ARCHITECT'S SUPPLEMENTAL INSTRUCTIONS

PROJECT:	Lee Lofts II – Tenant Space 2 Offices Salina, Kansas	Report No.	One (1)
OWNER:	Overland Property Group Dan Maximuk 234 N. Santa Fe Ave, Suite A Salina, KS 67401	Date	Oct. 14, 2024
CONTRACTOR:	MCP Group 3501 SW Fairlawn Rd. Topeka, KS 66614	Architect's Proj No.	24-3420
		Contract For:	General Construction Mechanical, Electrical

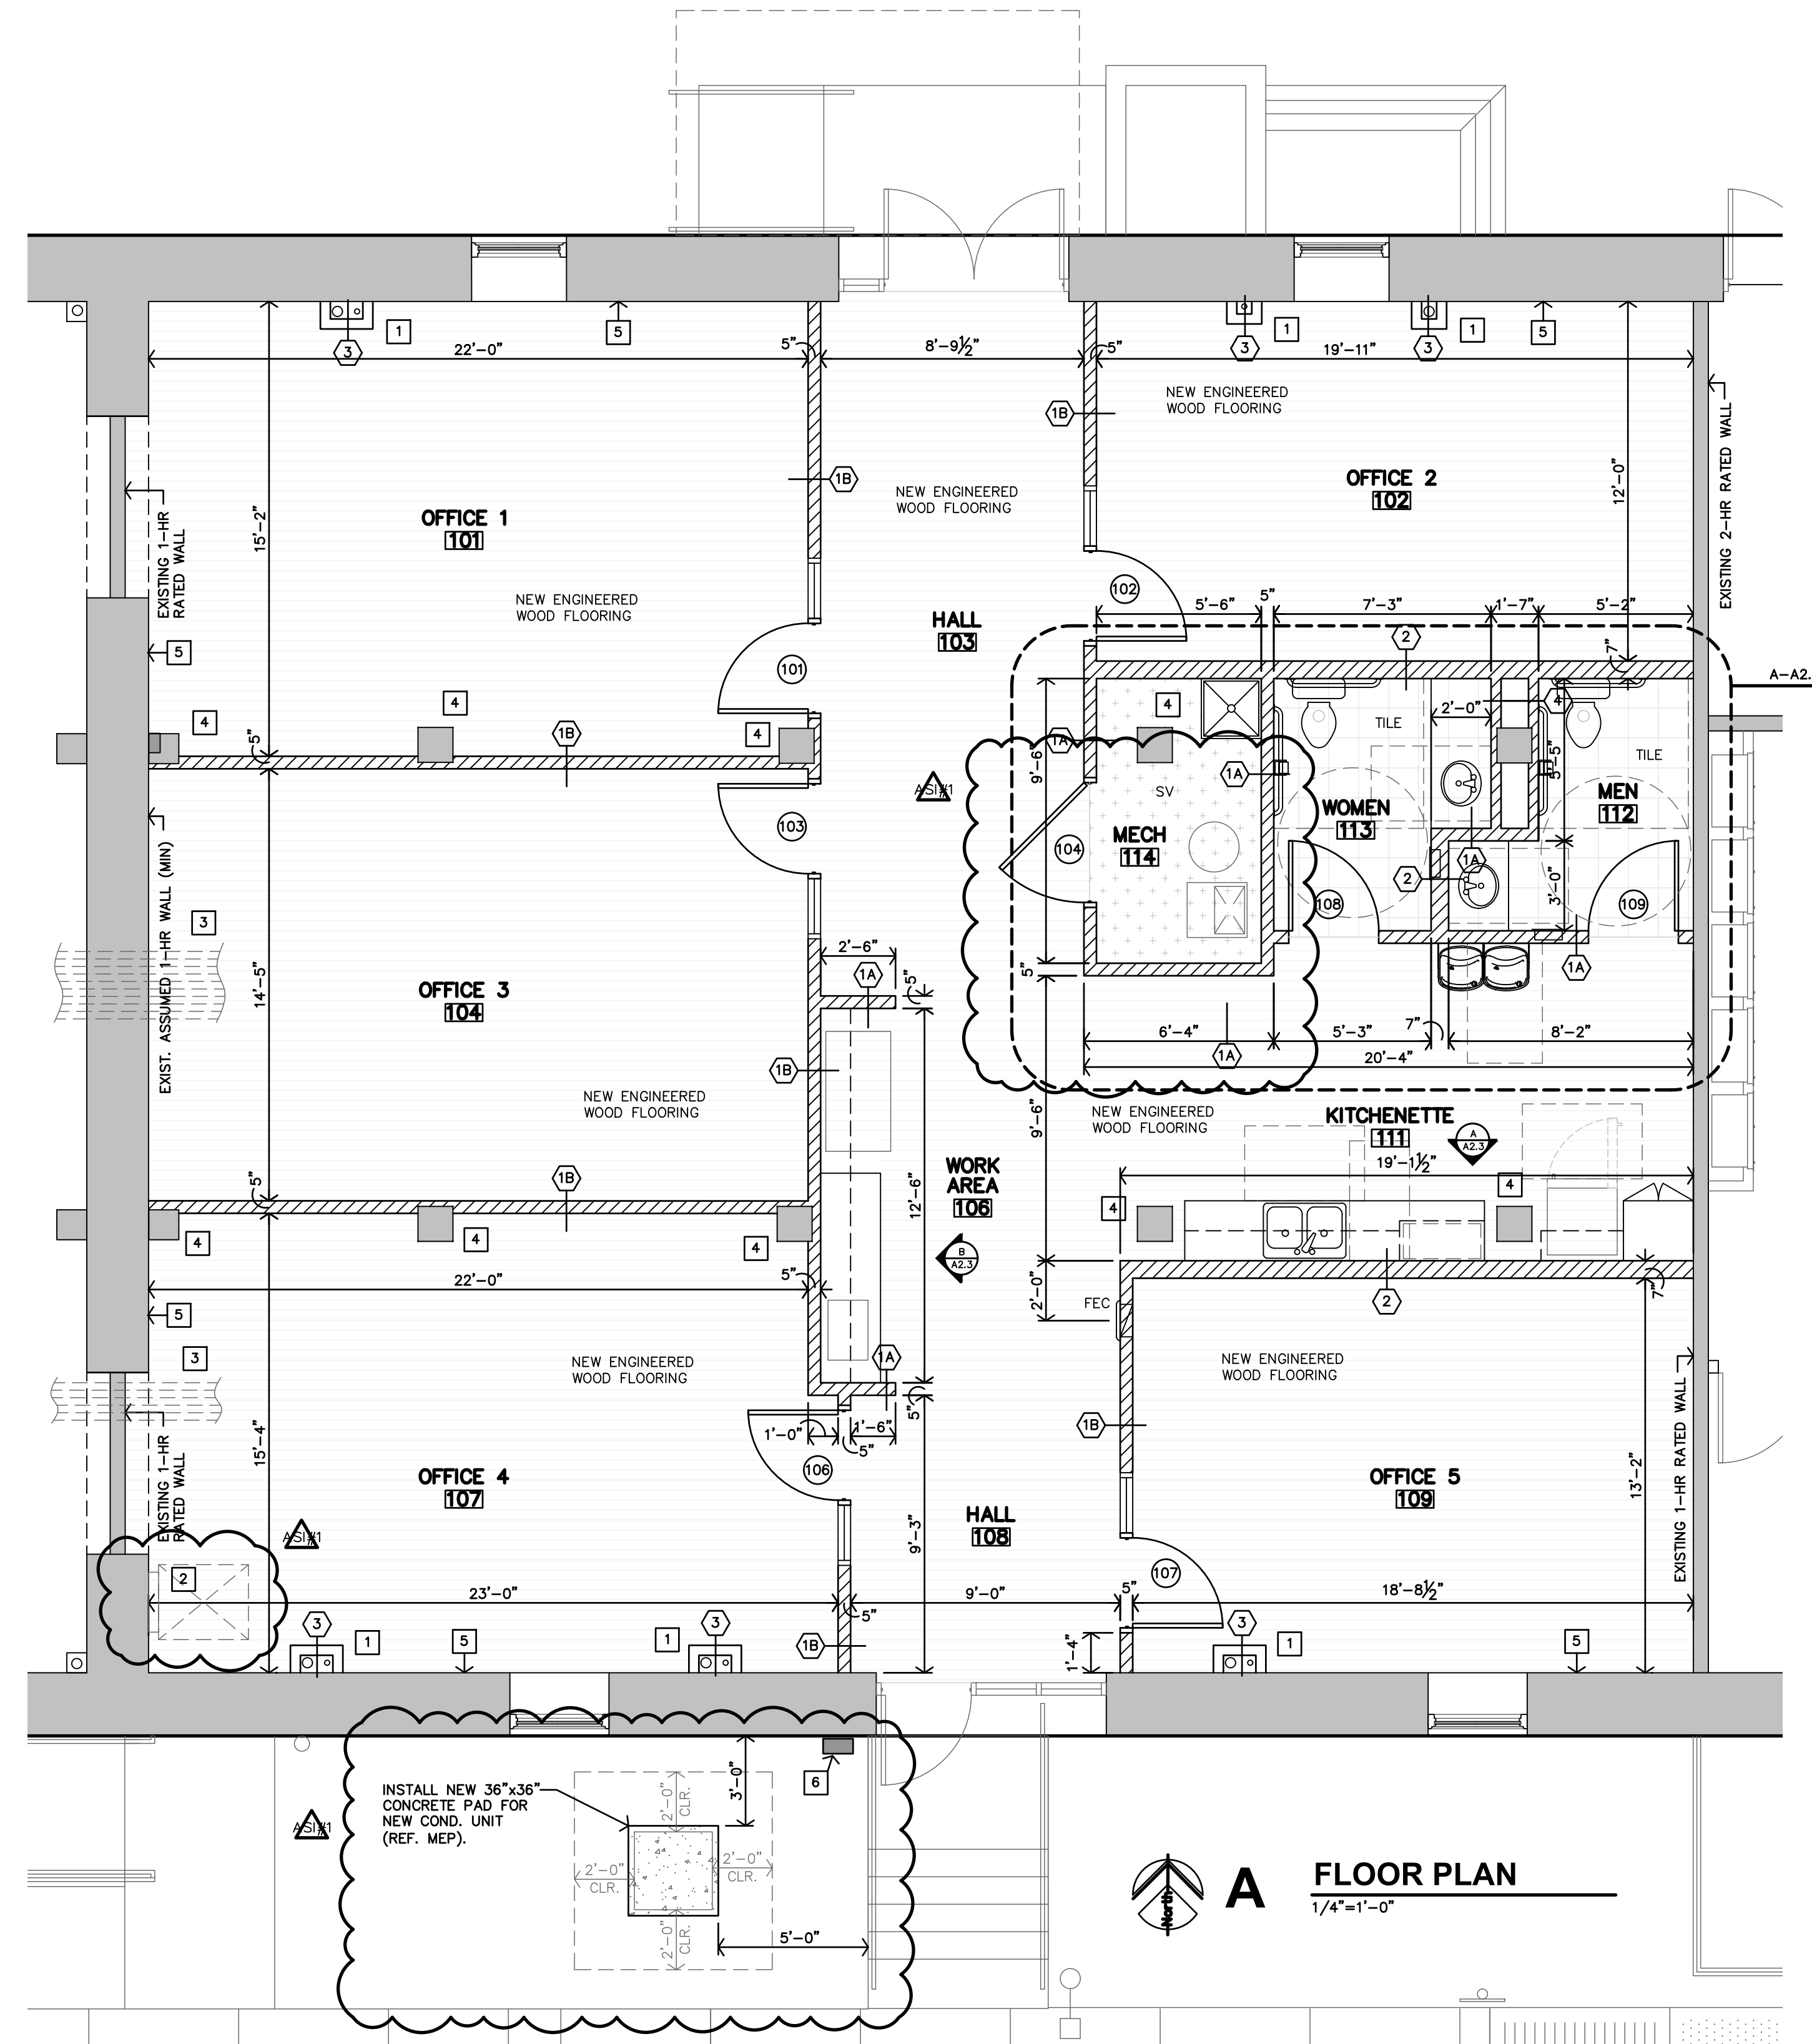
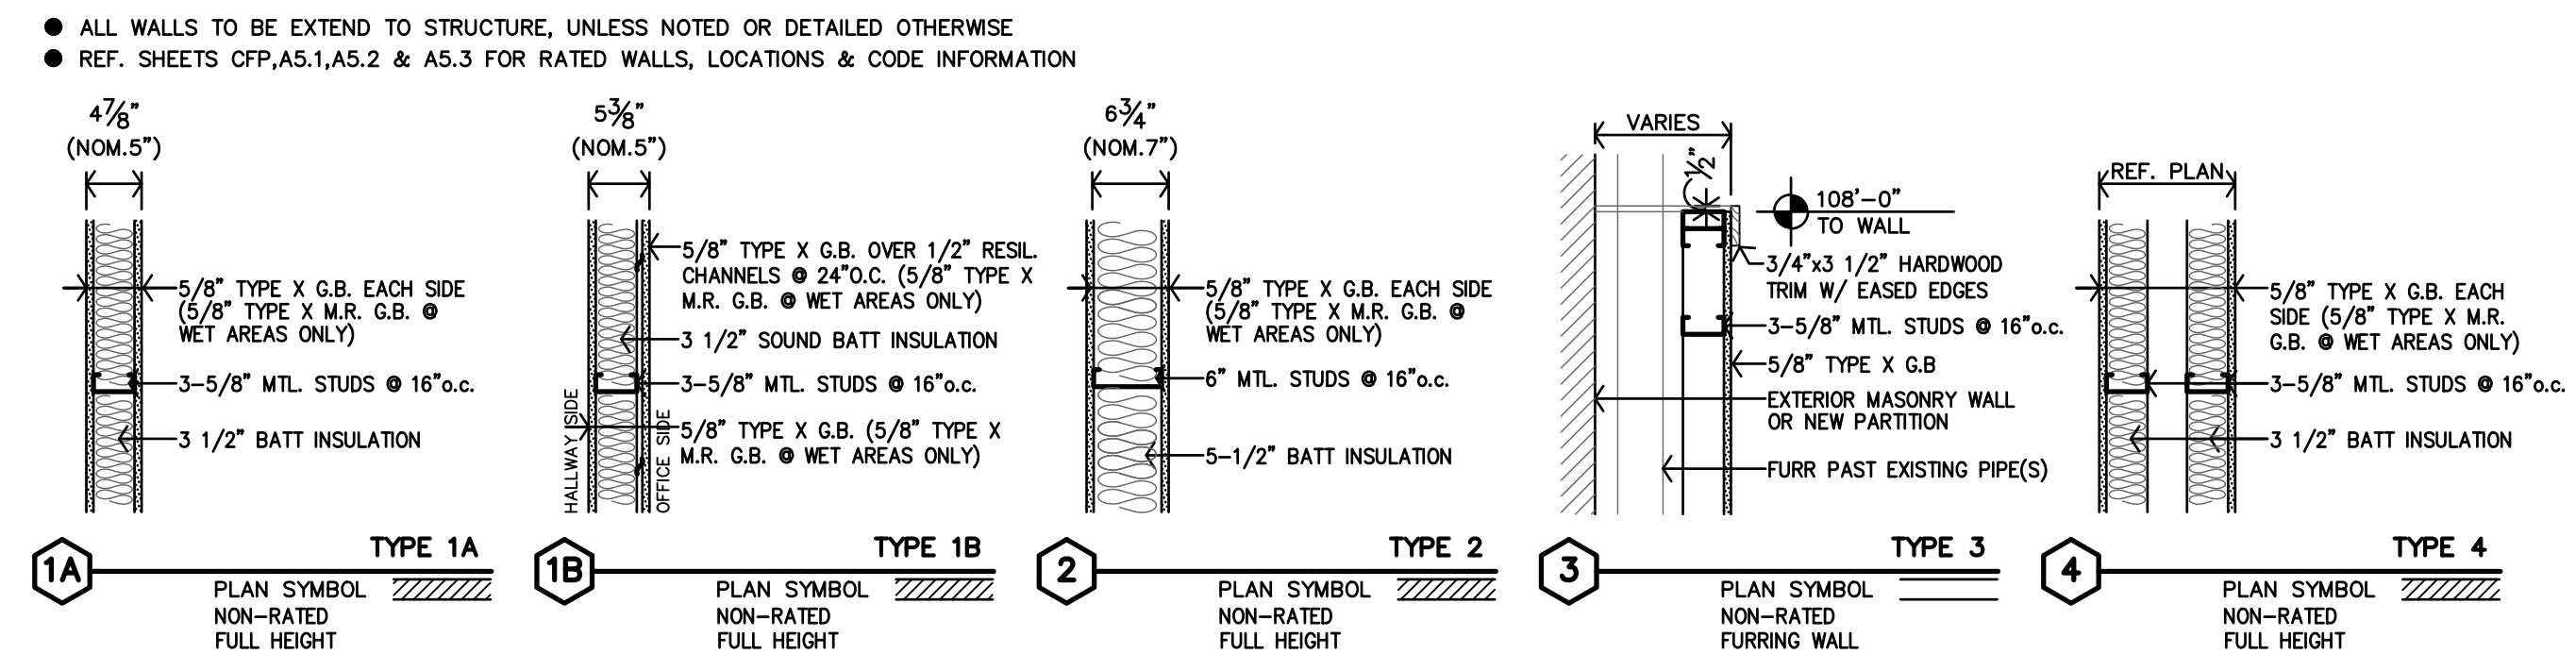
- 1) Contractor to make adjustments as needed and required per the modifications as indicated on attached drawings and in the below descriptions:
 - a. Sheet A2.1 – revised to show new condensing unit pad on grade, modification to mechanical closet size and door size, and electrical panel to remain in existing location.
